**COMMENTS IN OPPOSITION
MB DOCKET 04-19
FM TABLE OF ALLOTMENTS
TALLADEGA AND MUNFORD, ALABAMA**

MARCH 29, 2004

**ENGINEERING STATEMENT IN SUPPORT OF
COMMENTS IN OPPOSITION**

**Prepared On Behalf Of
Calhoun Communications**

FIGURE 1 - FM CHANNEL STUDY - 224A

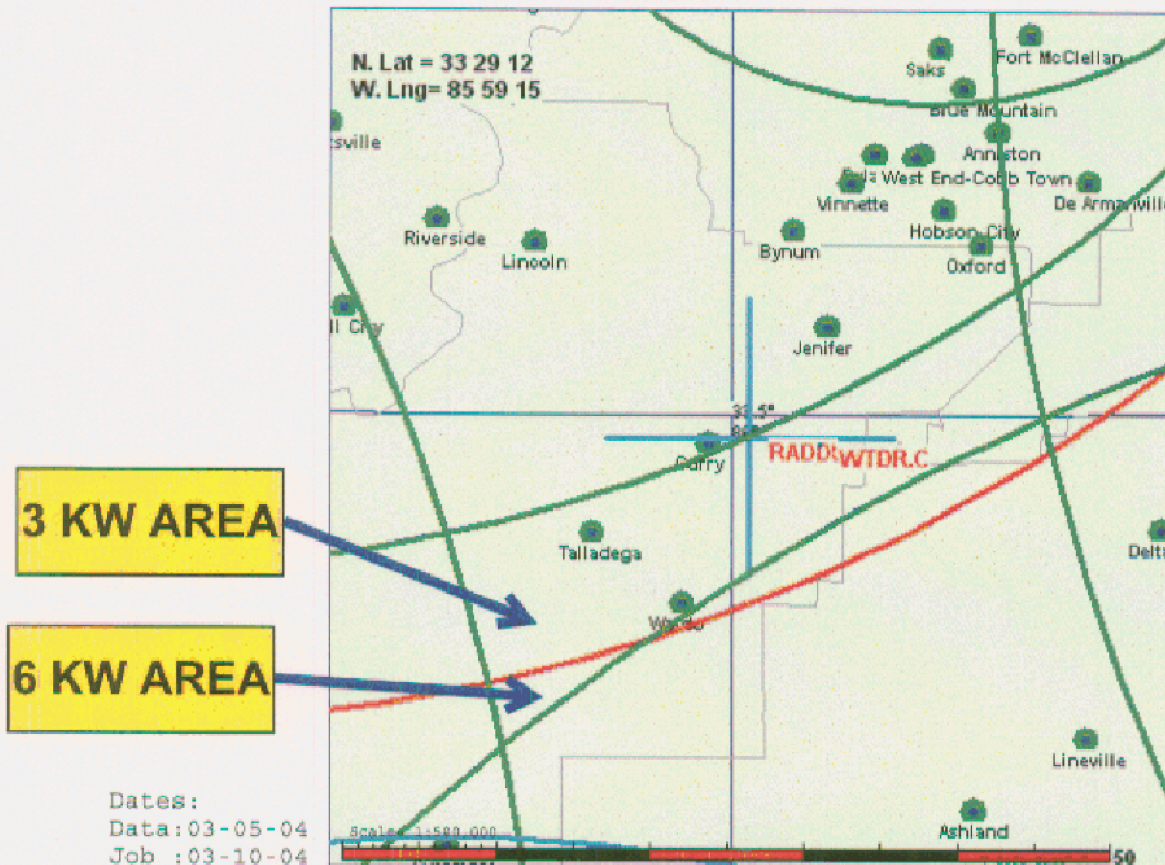
Figure 1 is a channel study which utilizes the licensed site (also NPRM site) of WTDR on Ch. 224A at Talladega. This figure indicates that the current site is **short spaced by 9.86 km** to WAFN on Ch. 221A at Arab, AL. With respect to WAFN the map in the upper portion of the figure shows the required separation for both 6 kW (114.5 km) and for 3 kW (104.5 km) operation. When originally allotted, Ch. 224A at Talladega only had to comply with the **old 3 kW rules**.

FIGURE 2 - ALLOWABLE AREA 224A

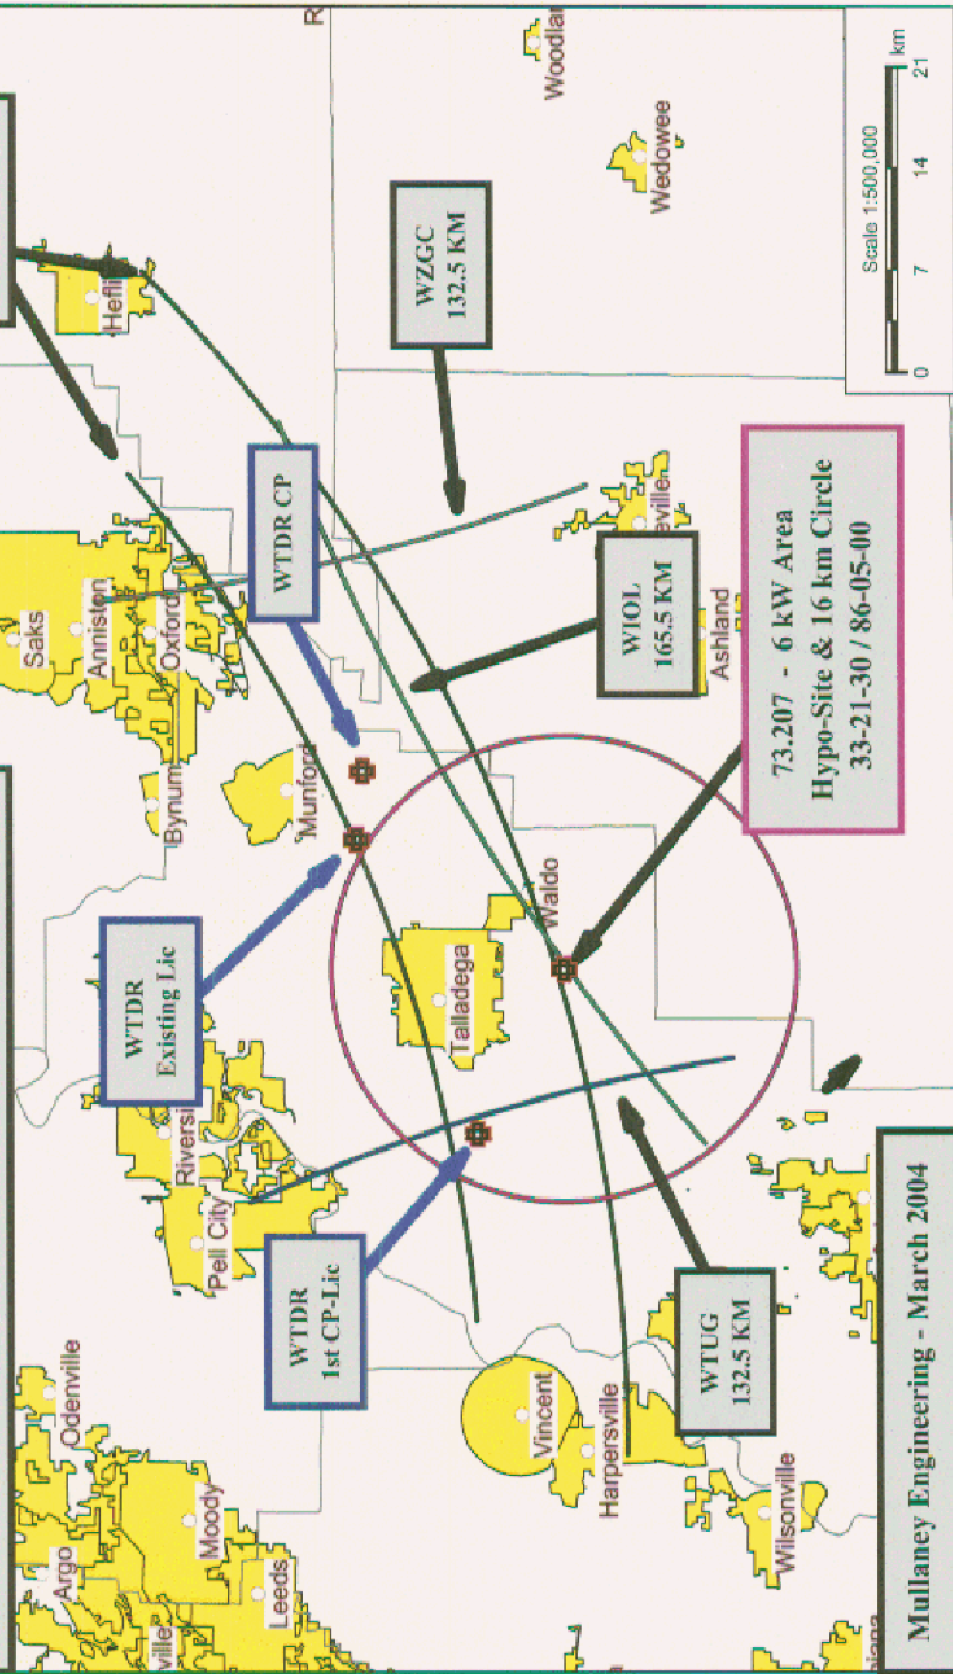
Figure 2 is an allowable area map depicting the required separations to relevant stations. This figure shows that there is an area some 9 to 14 km south-southwest of the city of Talladega which **fully complies** with the required separations for **6 kW operation**. A Hypothetical allotment reference site located at 33-21-30 / 86-05-00 easily places the 16 km allotment city grade circle over **100%** of Talladega. It should be noted that **none of the city of Munford** is close enough to the properly spaced 6 kW area to be within **any portion** of the Class A 16 km allotment circle.

Figure 2 also shows the originally licensed site of WTDR (was WEYY-FM) which was located some 10 km west of Talladega. However, in August 2000, WTDR sought and was granted a **change of site** which moved it some 12 km northeast of Talladega. In April 2003 (approximately 2 years & 4 months after building last licensed site), WTDR again sought to move and now **holds a CP** for a site which

FIGURE 3 **POTENTIAL SERVICE TO ANNISTON**

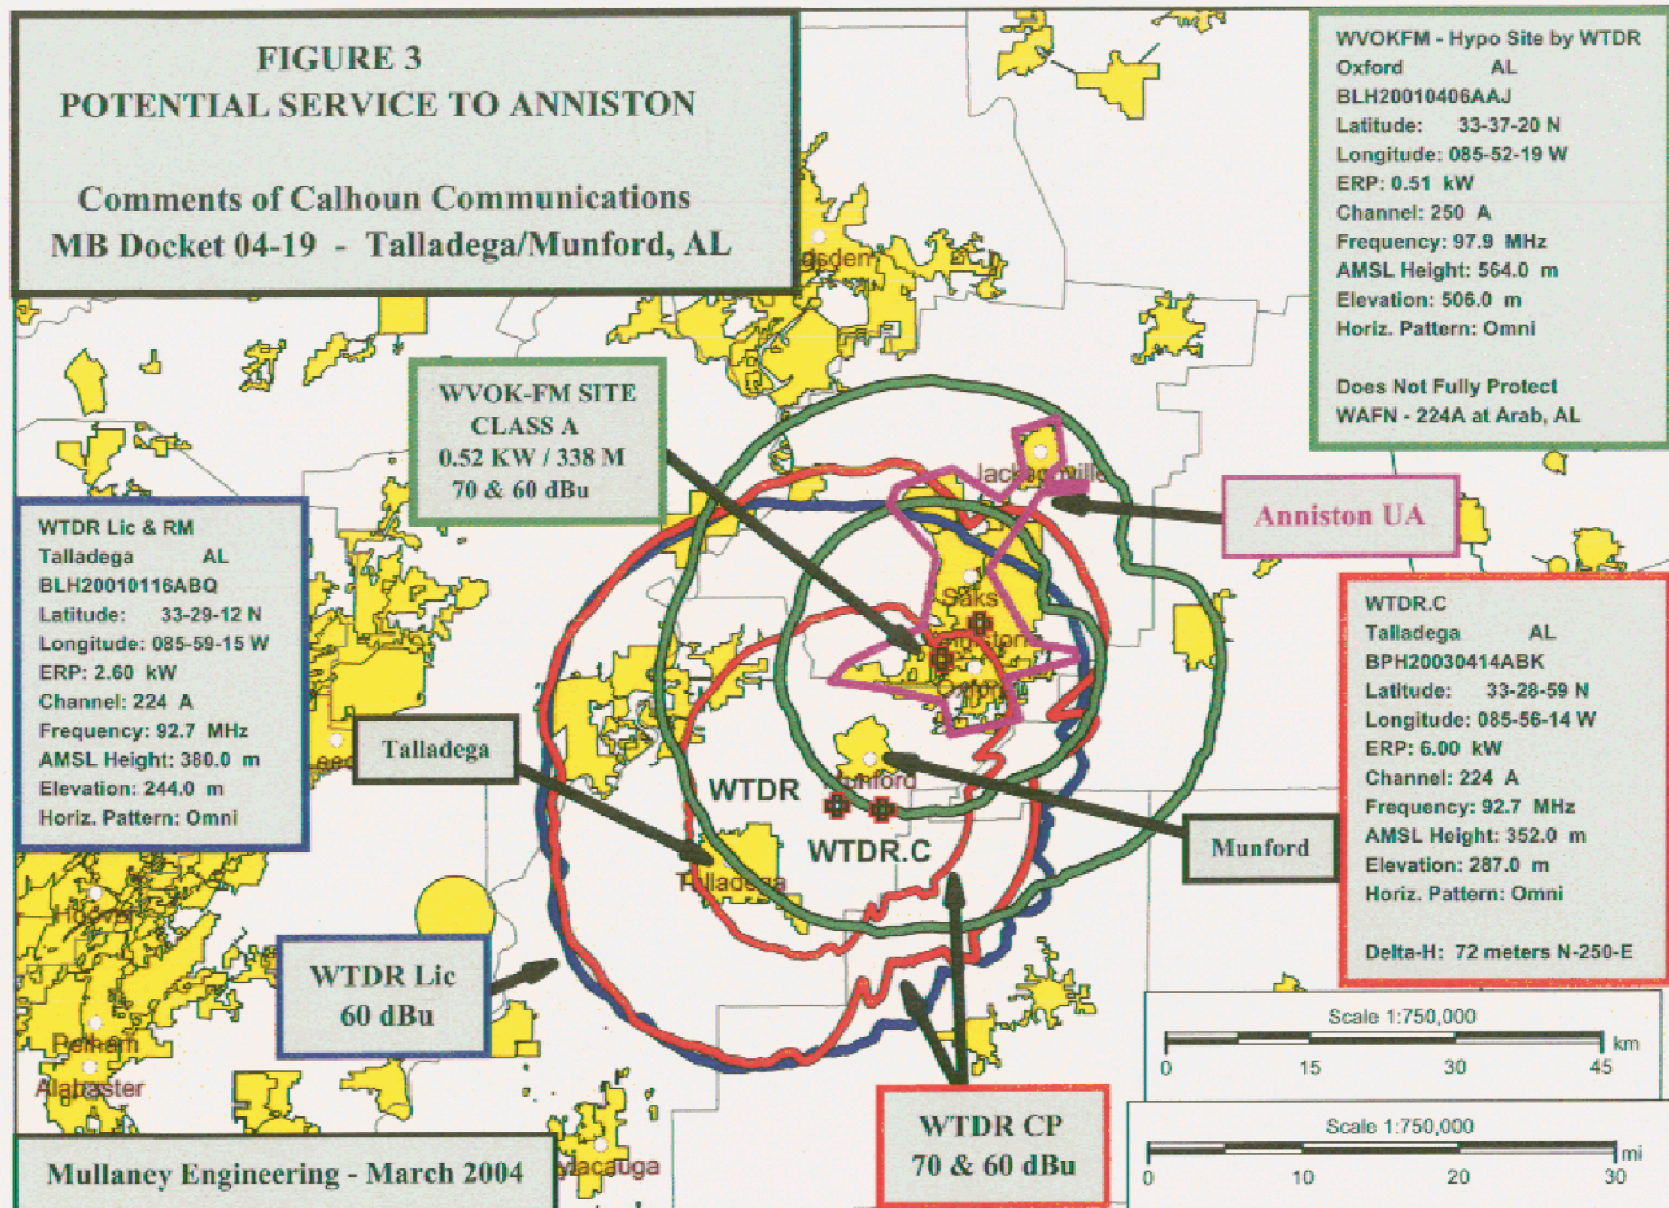
Figure 3 is a map showing the coverages of the License, the CP and a Hypothetical facility located on the existing tower of WVOK-FM. The Hypo WVOK coverage is based upon a non-directional antenna. The WVOK site would only be short spaced to WAFN as is the existing licensed site. Because of this **short spacing** it will be necessary for WTDR to utilize a directional antenna or to convince WAFN to modify its facility to comply with the rules regarding existing overlap. However, **regardless** of what is done with regard to WAFN, the power radiated in the direction of Anniston and of Munford **can be equivalent** to the 6 kW assumed herein.

It should be noted that the CP site currently authorized for WTDR is located about **as far from** Talladega as possible while still providing a city grade 70 dBu service to the city. It has been determined that the **Delta-H** from the CP site is approximately 72 meters in the direction of Munford and thus, WTDR **does not qualify** to use alternate coverage predictions to permit a site further from Talladega (and which is closer to Anniston). The WVOK site will provide a city grade 70 dBu contour to more than 50% of the Anniston Urbanized Area while also providing the required city grade service to Munford.
